1988 - 1989 Corvette: Hood Rubs Air Conditioning Hose

Source: Chevrolet Dealer Service Bulletin

Bulletin No: 89-183-1B

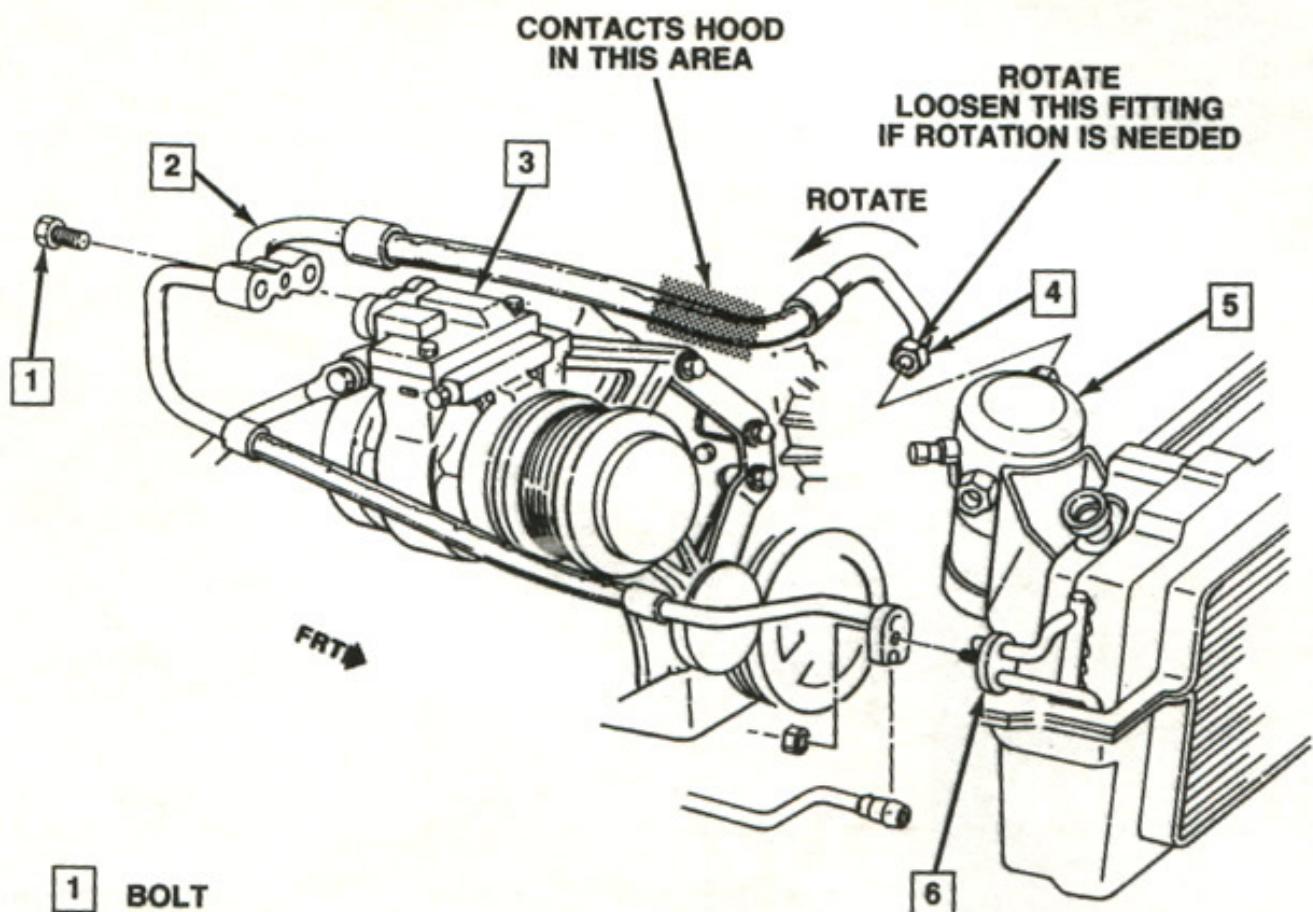
Some of the above vehicles, built prior to the breakpoint shown below, may exhibit a rub condition of the A/C hose to the underside of the hood. use the following procedure to check and address this condition. (Figure 1 shows hose disassembled for clarification only).

1. Check the area of A/C hose, as indicated in Figure 1, to see if it is contacting the hood. If there is no evidence of hose contact to hood, no further action is needed.
2. If the hose is contacting the hood but has not rubbed through the outer coating of hose, loosen the nut (item #4) on the accumulator (Item #5) and rotate the hose, in the direction indicated in Figure 1, to obtain clearance to the hood.
3. if the hose is rubbed through the outer coating, replace the hose assembly with one of the following service part numbers.

1988 10135634

1989 10135635
